E3645A-01

S E R V I C E N O T E

E3645A DC Power Supply

Display went off during power On.

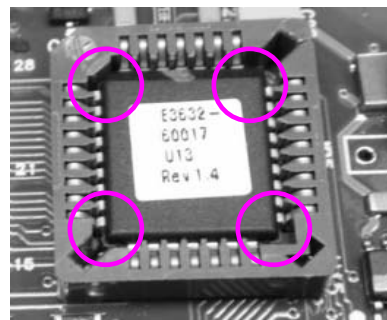
1. Upon turn on the power supply, if the symptoms are as follows:
 - a. Display light up and then become blank with fan running
 - b. Display light up and hang with fan running
2. Turn OFF the power supply.
3. Remove the existing EPROM and replace with a known good EPROM.
4. Refer to the reference designator of EPROM according to model:

5. Turn ON the unit again and see if the symptom disappears.
6. If the symptom still occurs, turn OFF the unit.
7. Return the unit to factory for Failure Analysis.
